# CITY OF MURFREESBORO PLANNING COMMISSION AGENDA

June 22, 2016  
1:00 PM

**MURFREESBORO PLANNING COMMISSION  
STAFF COMMENTS, PAGE 1  
JUNE 22, 2016**

Sheet Number:  
**LA1.20**

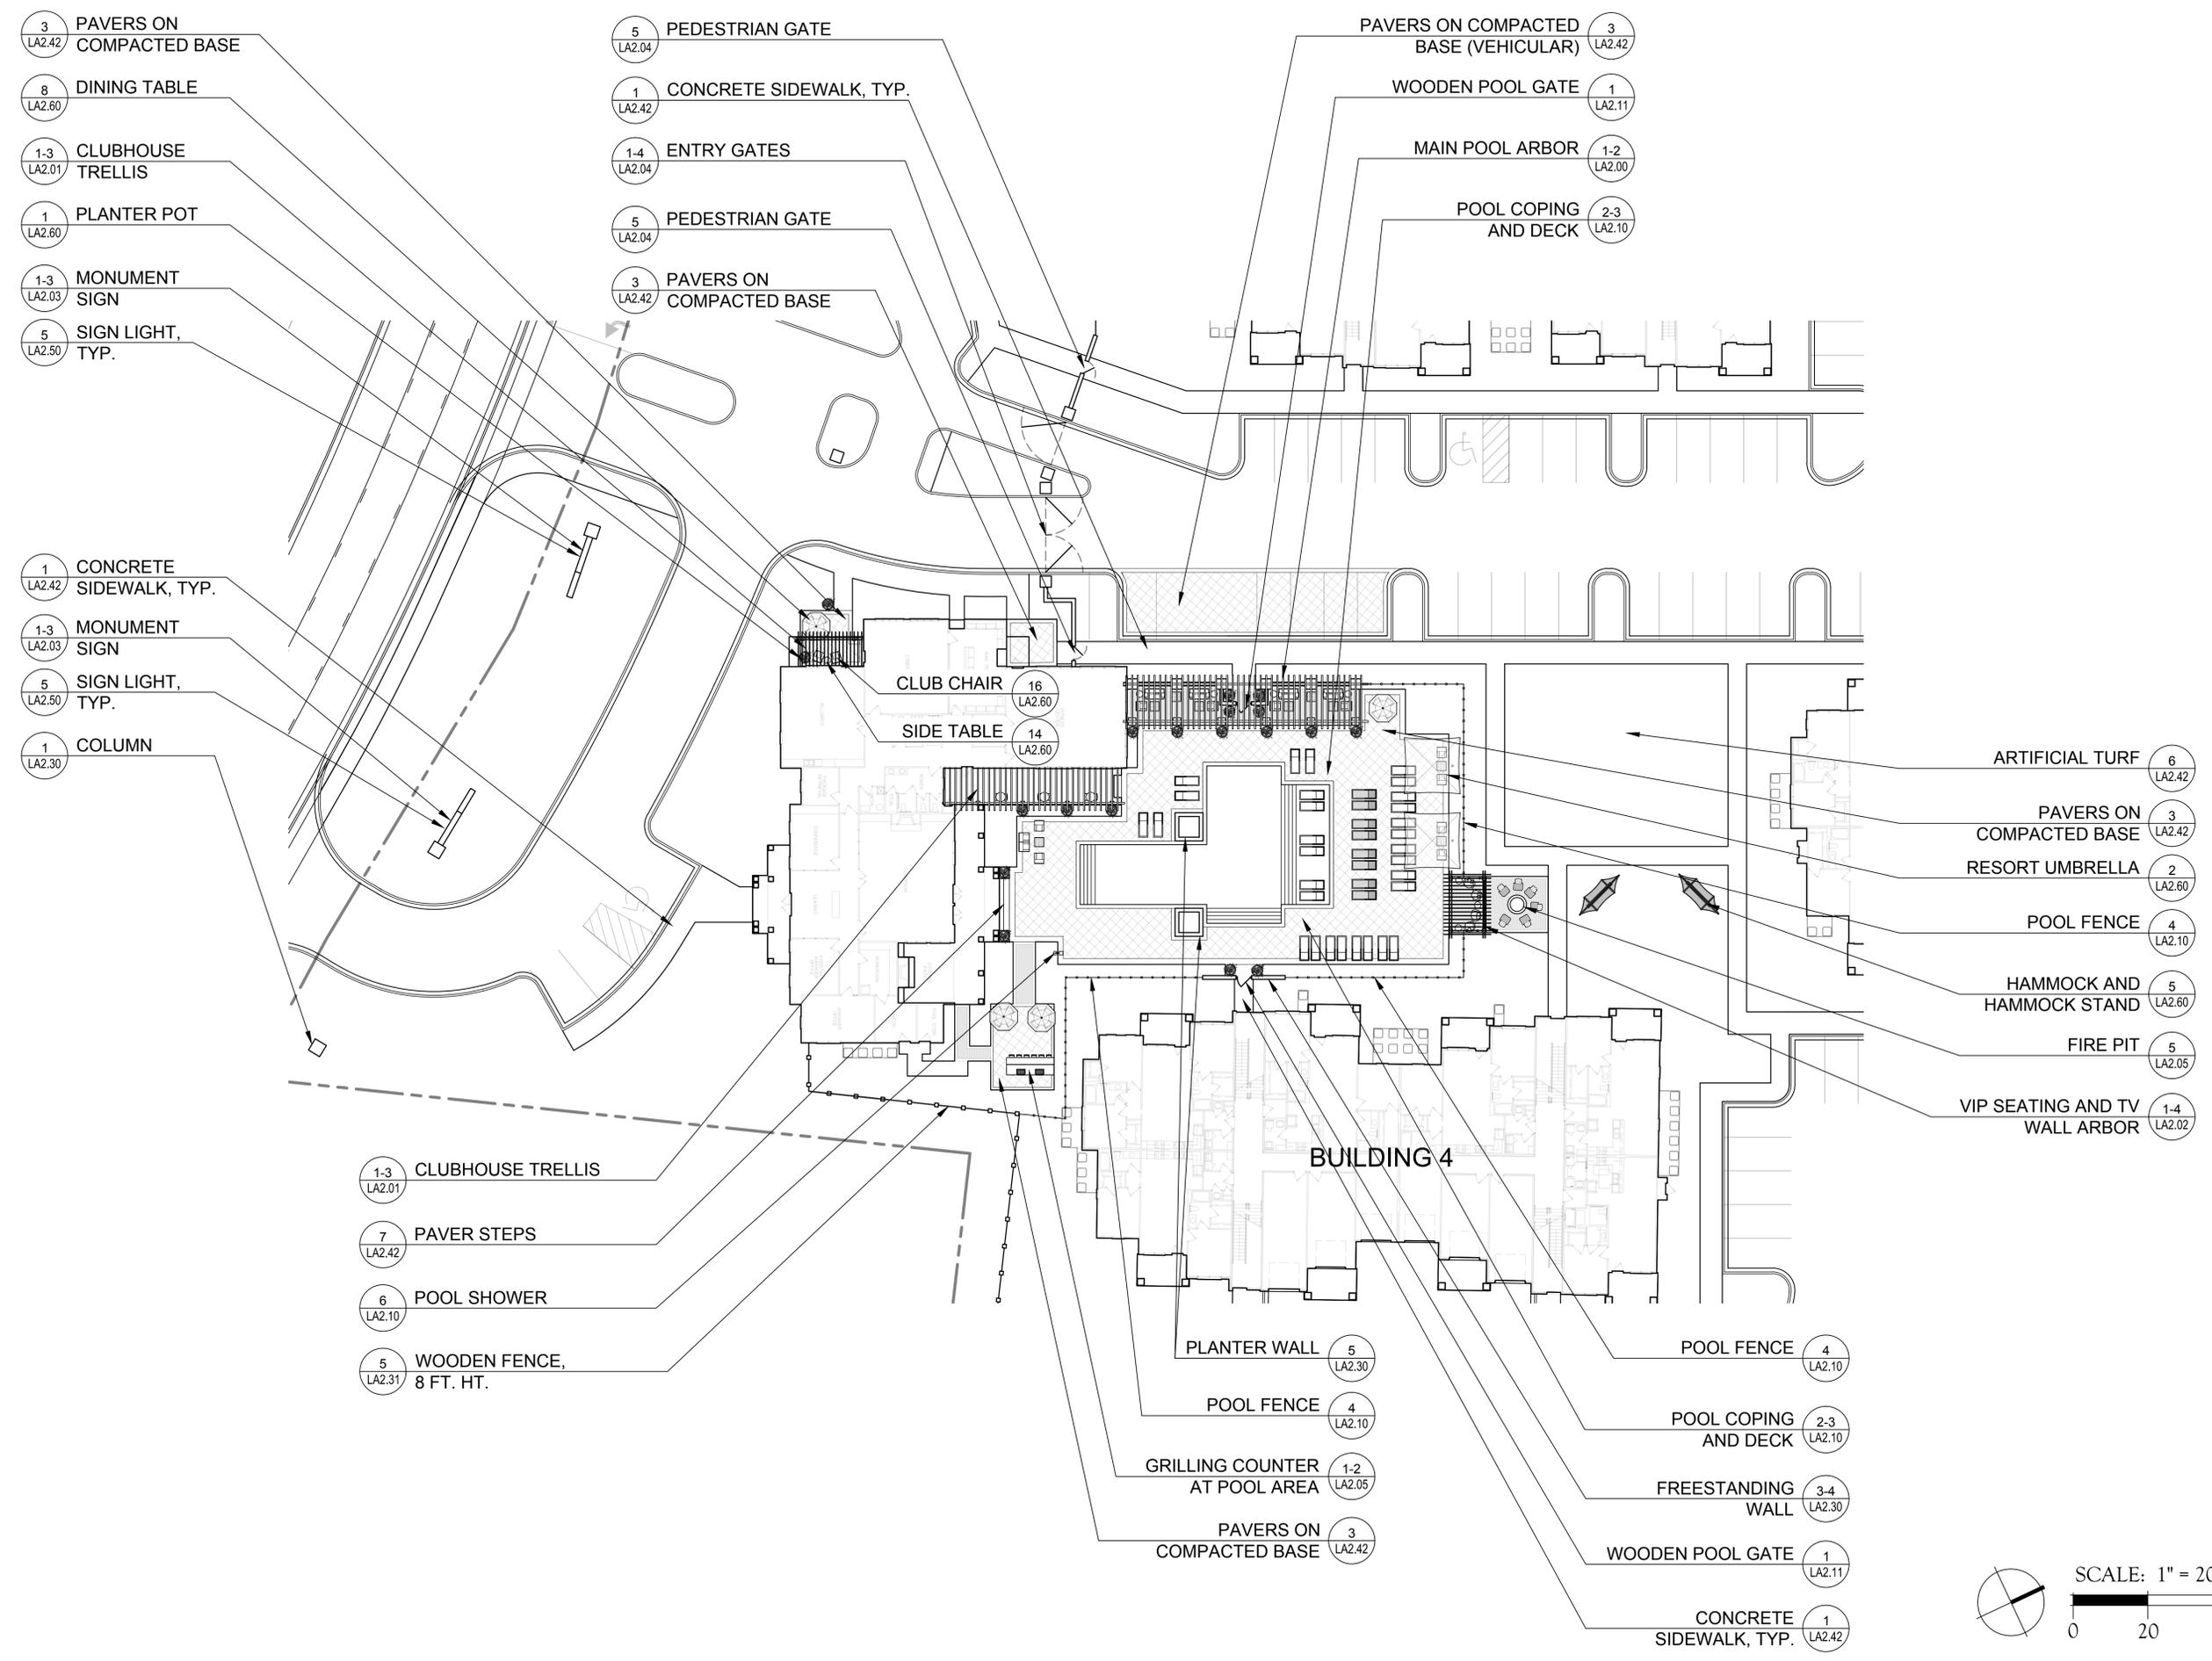
- 7) Provided calculations of required and provided open space and an area plan identifying areas proposed to be counted as open space. Verify that what is being counted toward the minimum open space requirements meets the criteria to be considered as open space, as specified in the GDO regulations. *The open space area plan on page C4.1 needs to identify the square feet of the areas as stated above.*

*area plan on page C4.1 needs to identify the square feet of the areas to demonstrate the minimum areas are being met. The formal open space elements should be included as callouts or details on the plans.*
